**Subject:** A346 RE: New application post - NYM/2022/0841 - Egton Slaughterhouse, High Street, Egton

**Subject:** RE: New application post - NYM/2022/0841 - Egton Slaughterhouse, High Street, Egton - Third Party

PROJECT TITLE:  
TE Offices, Egton

Proposed Plans

1 Proposed Ground Floor  
1:100

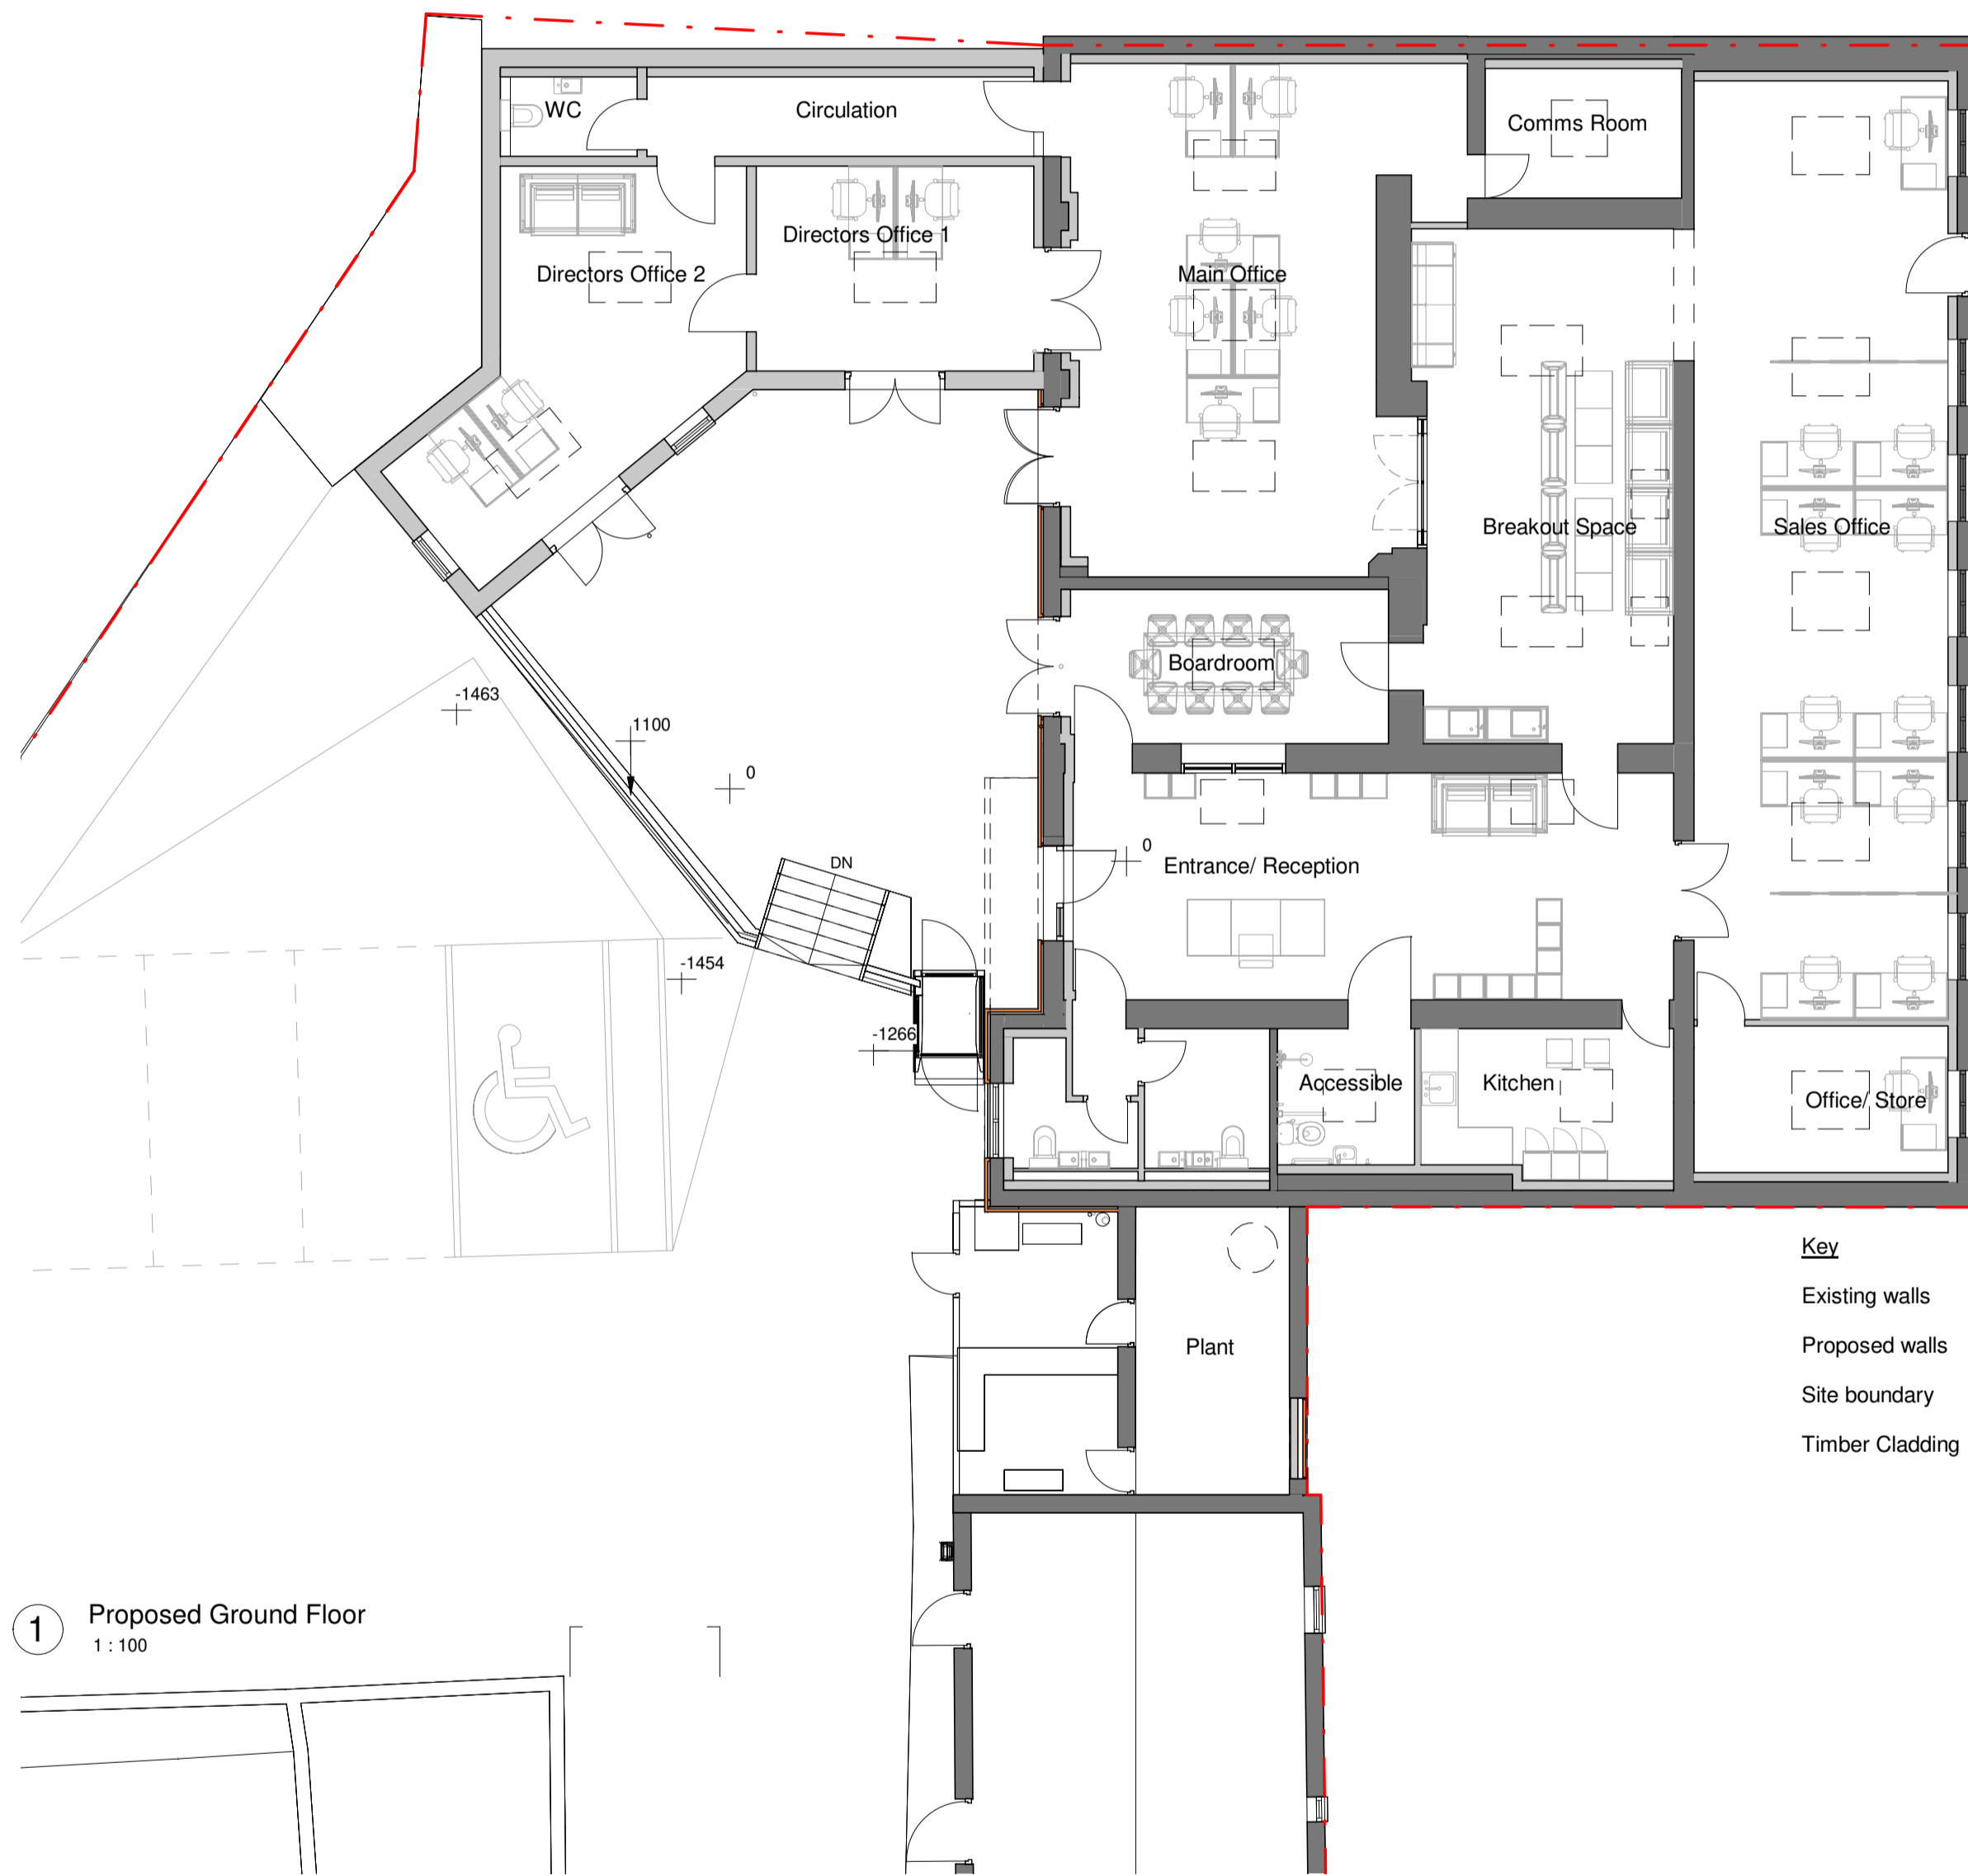
On drawing 10006 the site boundary is yet again shown incorrectly. The northern wall is a party wall, it is not 100% within the site boundary. This has been corrected previously but again has been shown incorrectly.

The northerly most proposed wall on drawing 10006 is shown as deviating from the boundary. This wall is already well under construction and does not follow this new route, it is hard up against the site boundary.

Please find attached a link to an updated 10006 rev P7 drawing with the boundary line corrected.

It's my understanding that there are 2 wall positions currently on site, one is the existing boundary retaining wall, (the remains of the demolished building) and the preparations for the northern wall of the directors' office suite , which angles slightly away from the boundary.

We are visiting site on Monday & can confirm exactly what is on site.

REV	DESCRIPTION	BY	DATE
P1	Planning Issue	KH	23.11.21
P2	Rooflights & roofs amended	NW	21.01.22
P3	Piggery retained. Note added re. solar film to rooflights	NW	11.02.22
P4	External wall lights, security camera & entrance access control locations added for AOD application	NW	13.10.22
P5	NMA application. Directors Suite footprint amended. Timber cladding indicated	NW	14.11.22
P6	AOD application. Revised external lighting. (Non NMA footprint)	NW	24.11.22
P7	NMA application. Red line boundary corrected to northern boundary.	NW	08.12.22
